SEPA's initial comments - Issue for amendment or further environmental justification		Applicant's response to SEPA	Applicant reasoning	SEPA's further response 11 October 2022	Applicant response 12 October 2022
<p>Turbine on deep peat when there is an area to the north that is not deep peat.</p> <p>Note recent submission indicates that there are other environmental and technical constraints in this area – it may be helpful to understand these further (and if they relate to our interests they may effect our opinion)</p> <p>Turning T directly adjacent to watercourse.</p>	 <p>Figure inserted above shows location of GWDTE in relation to Turbine T1 sited for Proposed Development, acting as a constraint on micro-siting.</p>	<p>Turbine T1 relocated east to 287093 835457 to avoid as much peat as possible. This reduces the amount of peat that will be excavated in this location by 1,220m<sup>3</sup>, from the previous volume of ~7,370 m<sup>3</sup> to ~6,150 m<sup>3</sup>. The relocation also moves the infrastructure away from the GWDTE and the topography associated with the feature.</p> <p>The turning head has also been moved closer to the turbine hardstanding and away from watercourse and r

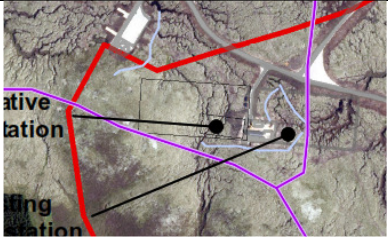
<p>Access track to turbine on deep peat although there is no peat and disturbed ground to the north and an existing track part of the way to the west.</p>		<p>This area (inserted left) was the location for the construction compound for the Operational Scheme. The Applicant does not have legal control to site <i>permanent wind farm infrastructure</i> (i.e. turbines or internal access tracks) in an area which is demarcated in a legal agreement for the siting of a decommissioning compound by the owner of the Operational</p>	<p>Not offered for reasons set out.</p>	<p>Reason relating to use of area as construction compound as an interim arrangement before that area becomes the decommissioning compound understood.</p> <p>Slightly less clear that some tracks may be designated as “for use in restoration” and that new development not have access to them, yet all the other track the new development does have</p>	 <p>The yellow rectangle above is the area defined as the 'Laydown Area' for turbine components for the Operational Scheme, and which the Applicant can only use for the location of a <i>temporary construction</i></p>

SEPA's initial comments - Issue for amendment or further environmental justification		Applicant's response to SEPA	Applicant reasoning	SEPA's further response 11 October 2022	Applicant response 12 October 2022
		Scheme. The owner of the Operational Scheme has also identified this area as a 'laydown area' for turbine components (storing blades, nacelles, gearboxes etc.) in case urgent upgrades are required during the operational lifetime of the Operational Scheme. A temporary construction compound in this area for the Proposed Development is acceptable to the owner of the Operational Scheme.		access to. Even if the turbine cannot be located in the area where the decommissioning compound will be located can it not be located directly adjacent and can it not make use of one of the existing tracks to it?	<i>compound</i> for the Proposed Development. This shows why permanent infrastructure cannot be sited in this area (the black outline below the yellow rectangle is turbine T3 & crane pad/access track for reference); there is simply no space taking into account that the Applicant does not have legal control to site infrastructure in this area. This is also the most recent aerial image available, and shows how the land has recovered since construction of the Operational Scheme was completed.

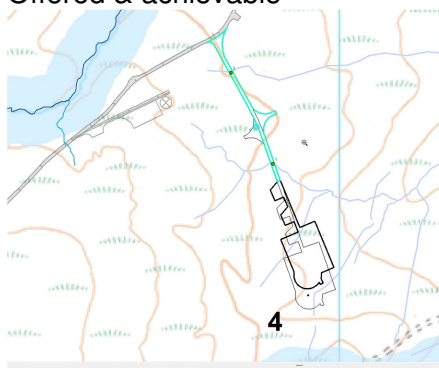
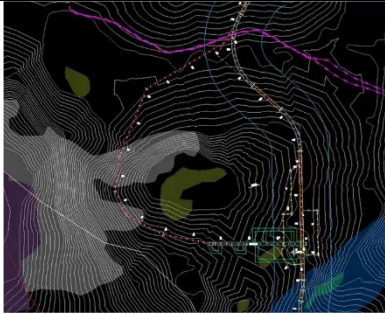
Consideration only given to site being to the west of current substation – other areas might have shallower peat.  Possibility to extend existing substation or locate directly adjacent to it so no new disturbed peat.		The Applicant has no legal control for areas east of existing sub-station for Tom nan Clach Wind Farm. The location for the Proposed Development, adjacent to existing sub-station, mitigates the Landscape Visual impact by not creating any 'gaps' between these two buildings. The design principle underpinning the Proposed Development is for it to be seen an Extension to the Operational Scheme in Landscape Visual Impact terms. The existing 'as built' substation is shown in the image, and where the Proposed Development substation is located.	Not offered for reasons set out.	The location of the new sub-station directly adjacent to the existing substation would be acceptable to us.

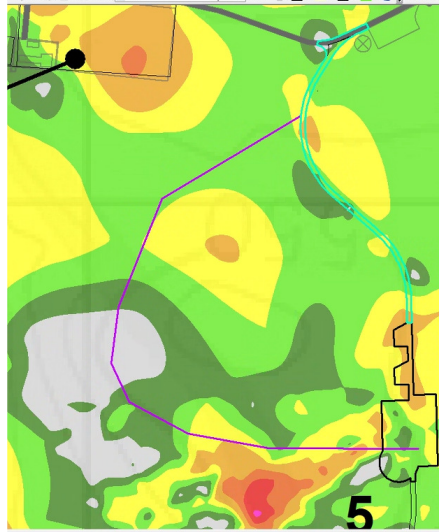
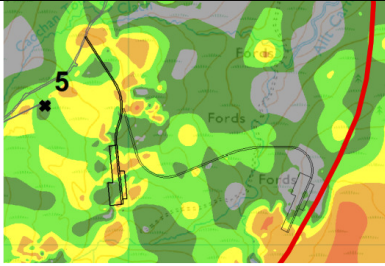
SEPA's initial comments - Issue for amendment or further environmental justification		Applicant's response to SEPA	Applicant reasoning	SEPA's further response 11 October 2022	Applicant response 12 October 2022
<p>Can you provide any further evidence (site photographs?) to support the proposal that these water features are man-made drains rather than natural water features that the layout needs to avoid?</p> <p>Note recent submission indicates peat gullies or manmade drainage will be diverted or restored (which is acceptable).</p>	<p>Below: Linear man made ditches that will be diverted around hardstanding</p>  <p>Below: more natural watercourse to the south that will remain intact due to relocation of T4 to the north</p> 	<p>Turbine T4 has been relocated 32m north. This avoids the natural water feature to the south and allows the man-made drain to be diverted pre-construction. The turning head has also been moved to the east of the track to avoid the small pool.</p>	<p>Offered &amp; achievable</p> 	<p>Supportive of proposed change</p>

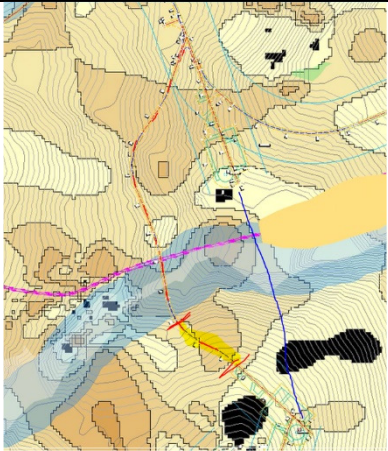
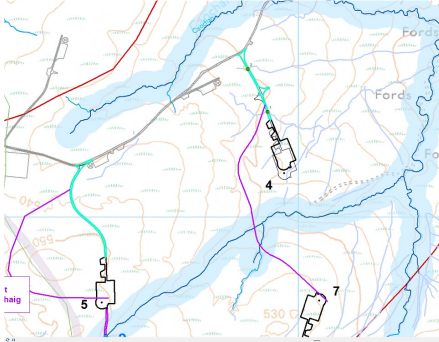
<p>A change in orientation of the supporting infrastructure could move it onto the shallower eroded peat, avoiding areas with intact vegetation cover and deeper peat.</p>		<p>Repositioning the crane pad to the west would require a new internal access track to be designed (see image, red curved line/existing track also shown). This is the only acceptable option in civil engineering terms to follow the steep gradients present to ensure the track is not too steep (&gt;10%), once you have repositioned the crane pad to connect to the existing access track. There are restrictions in the south of the red-line/legal boundary which limit alternative internal access track options. The presence of deep peat in the west and south, once the crane pad has been repositioned, does not</p>	<p>Not offered for reasons set out.</p> 	<p>Thank you for investigating and explaining. Current layout in this area seems to be the better option.</p>

SEPA's initial comments - Issue for amendment or further environmental justification		Applicant's response to SEPA	Applicant reasoning	SEPA's further response 11 October 2022	Applicant response 12 October 2022
		allow for the design of turning heads (not permitted in HSE terms). Repositioning the crane pad to the west would increase the length of access tracks required by >400m. A change in crane pad orientation would not achieve the desired outcome, it would increase the environmental impacts (increase in peat depth) and be unacceptable in civil engineering & HSE terms.			
Existing track directly to Turbine but new track proposed.		The Applicant did look at three possible options in achieving this in earlier site iteration of the internal access tracks. All options would dissect a GWDTE. What became the preferred option (in environmental/civil terms, inserted and see document ' <b>TNC – T4 &amp; T6 Plan' attached</b> ) the turning head is located on a 10% vertical gradient (not permitted in HSE). The cut required for the track and hardstanding (@4m deep at the worst point) will have a knock-on effect on the existing tracks. The cut for this would create a ponding area which would need to be drained. Where the cut is located is where the existing 33kV underground cable connecting the Operational TNC Wind Farm is located (see <b>Figure 2.0 – Design Freeze 9</b> of the EIA Report). Designing &	Not offered for reasons set out.	Thank you for investigating and explaining. If new track is to be included suggest final submission includes offer to rationalise new and existing tracks so that the overall length of tracks on the site is limited. Would be helpful if this included plan showing what existing tracks will be restored.

SEPA's initial comments - Issue for amendment or further environmental justification		Applicant's response to SEPA	Applicant reasoning	SEPA's further response 11 October 2022	Applicant response 12 October 2022
		constructing an internal access track over a live underground 33kV cable is challenging but acceptable with appropriate mitigation (which the track North of Turbine T5 has incorporated). 4m of cut in this location, where the underground 33kV cable can be buried @1m deep (min. permitted is 600mm), presents an unacceptable commercial risk (the Operational TNC Wind Farm would need to be switched off, whilst any install/construction takes place for an undefined amount of time). The proposed new track does not achieve the outcome desired, and was discounted during the Design Iteration process for the Proposed Development.			
Access track from T5 to T7 is over deep peat. An alternative access from T4 to T7 would be shorter – more probing information required to consider this alternative further.		<p>Proposed track directly connecting Turbines T4 to T7 is not possible in civil engineering/turbine delivery (as the gradient exceed 20%). The alternative option (see red line image inserted) is 750m in length compared to 800m in length for the current proposed track between T5 and T7.</p> <p>The alternative would be also be over deep peat (1.5-2m) and therefore similar to the existing T5 to T7 route would need floating road sections. In addition, the steepest gradient on this option is @12% which for some turbine suppliers is too</p>	<p>Not offered for reasons set out.</p> 	Thank you for investigating and explaining. Current layout in this area seems to be the better option.
